February 15, 2013

**Re: Amendment to Report of Waste Discharge (ROWD); Feather River Organics Compost Facility; Waste Discharge Requirements Order R5-2003-0093 (WDR Order); Recology Yuba-Sutter; Yuba County, CA**

**RE: SUBSURFACE CHARACTERIZATION OF THE COMPOST PAD AT THE RECOLOGY YUBA-SUTTER FACILITY, MARYSVILLE, CALIFORNIA**

**FIGURE 1**

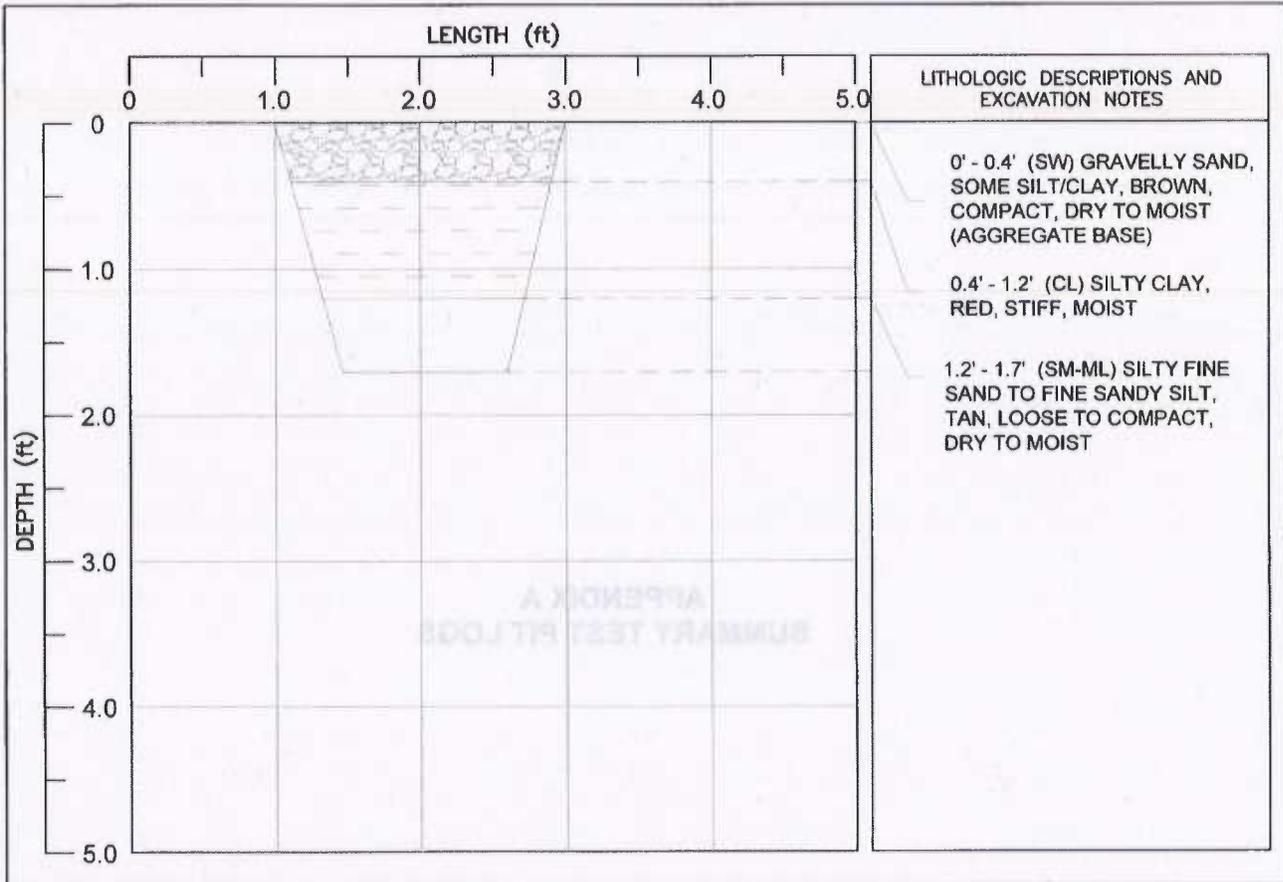
As part of its investigation, Golder evaluated four different areas of LF-1, which are depicted in Figure 1 of its report:

- The area with a vegetated cover where composting operations do not occur (Area 1 - Vegetated LF-1 Cover).
- The composting area with an aggregate base pad, which was the subject of the 2001 Golder study (Area 2 - Original Compost Pad).
- The composting area where an aggregate base pad was installed after 2001 (Area 3 - Compost Extension Pad). The composting pad in this area was constructed to meet the specifications outlined in the 2001 Golder study.
- The compost storage and staging area, which currently is not surfaced with a low-permeability aggregate material (Area 4 - Compost Storage Area).

The new Golder investigation found that the moisture content in the soils underlying the areas where composting operations occur (Areas 2-4) were either similar to - or less than - the moisture content in the

Based on its investigation, Golder recommends the following actions to improve the performance of the LF-1 cover in helping to impede water filtration: (a) adding aggregate base material to Area 2 (Original Compost Pad) to restore the thickness of the pad to a minimum of 0.5 feet in accordance with the technical specifications in Golder's 2001 study; (b) improving Area 4 (Compost Storage Area) by adding a low-permeability aggregate base material to a minimum thickness of 0.5 feet; (c) periodically verifying the aggregate base thickness in Areas 2, 3 and 4, and restoring this aggregate base as necessary; (d) periodically grading the compost pad. Recology is committed to implementing these recommendations in a timely manner.
